Re: 13CVCP100X
899 Westchester Avenue
Remedial Action Work Plan (RAWP) Stipulation List

Brinkerhoff Environmental Services, Inc. of New York hereby submits a Remedial Action Work Plan (RAWP) Stipulation List for the Site to the New York City Office of Environmental Remediation (OER) on behalf of Mastermind, Ltd. This letter serves as an addendum to the RAWP to stipulate additional content, requirements, and procedures that will be followed during the site remediation. The contents of this list are added to the RAWP and will supersede the content in the RAWP where there is a conflict in purpose or intent. The additional requirements/procedures include the following Stipulation List below:

Appendix 3
Composite Site Cover Design and Location

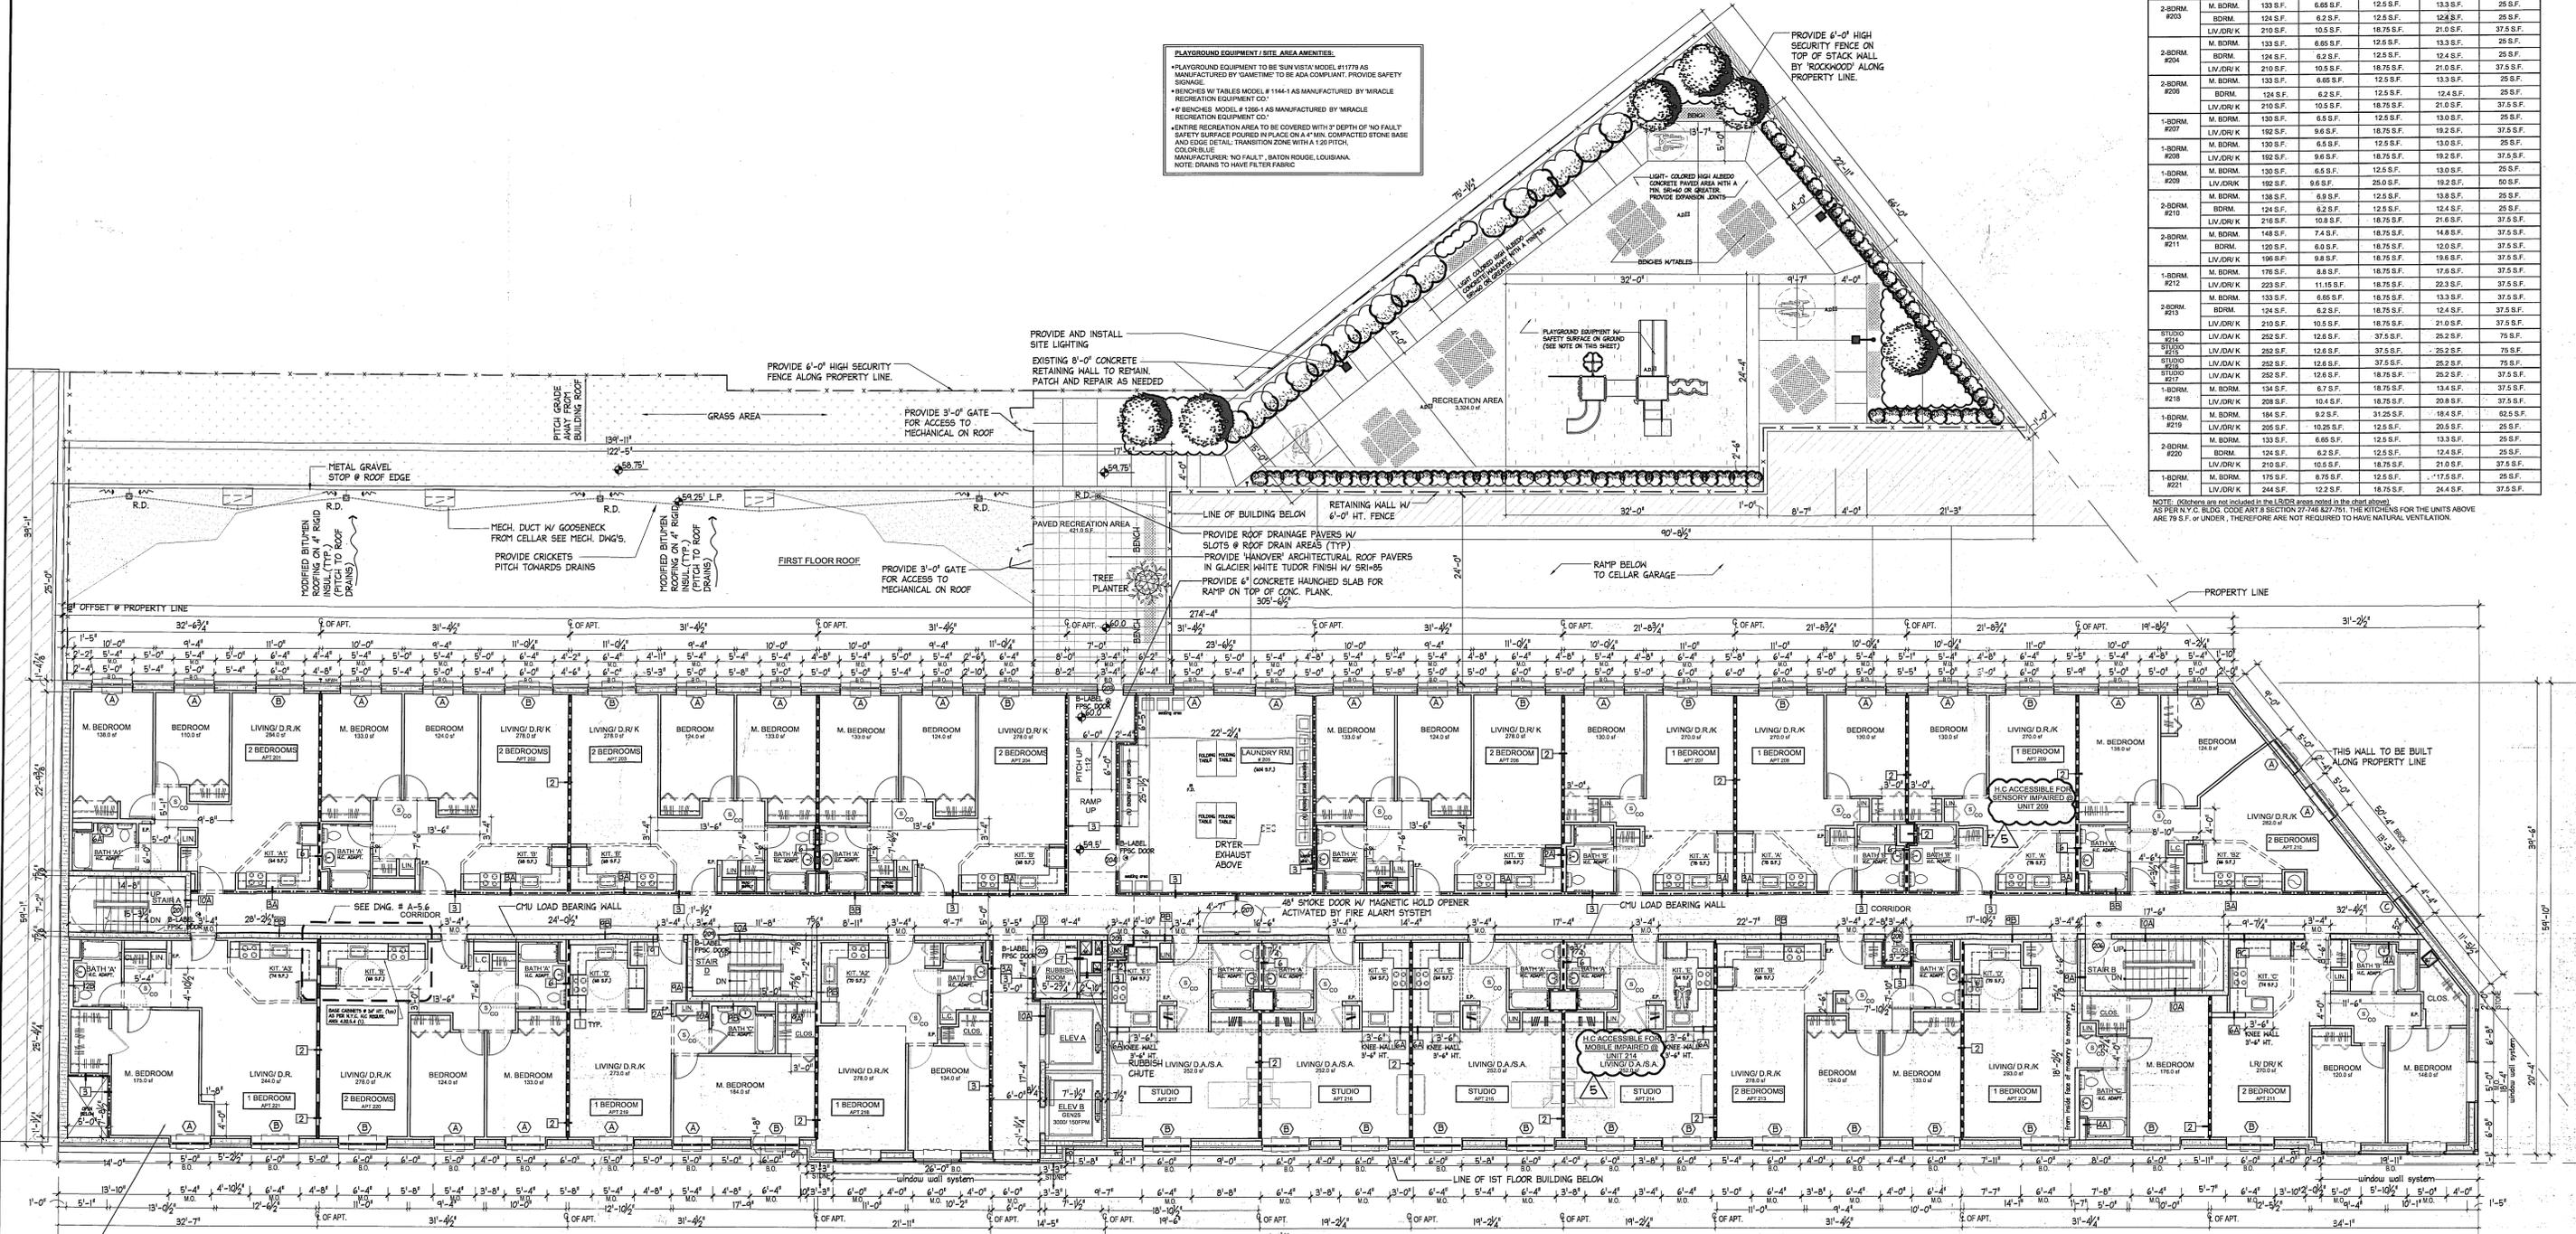
7. An engineered composite site cover will be placed over the entire footprint of the Site. The composite cover system will be comprised of concrete covered sidewalks, 4" to 6" concrete building slab. A 4" to 6" concrete slab with rubber pavers will cover the second floor recreation area. PE/RA certified drawings of the composite site cover are provided as **Appendix 3**. Sheets A1.2 and A1.3 in **Appendix 3** shows the typical design for the remedial cover type to be used on this site and the location of each cover type to be built at the site, respectively.

Appendix 4
Moisture Barrier Manufacturer Specifications

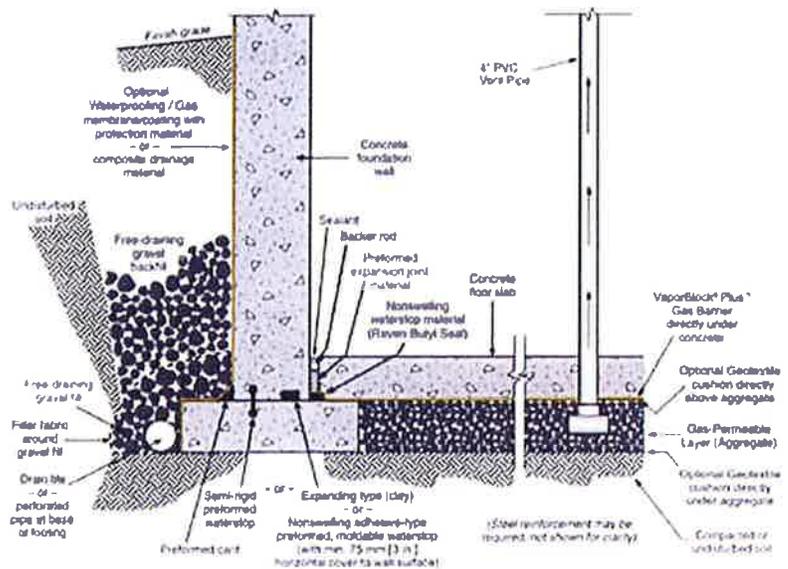
8. The moisture barrier planned for this project is 20 mil HDPE as manufactured by Raven, (or equivalent) to be installed beneath the structure's slab and along the foundation sidewalls. The manufacturer specifications are attached as **Addendum 4**.
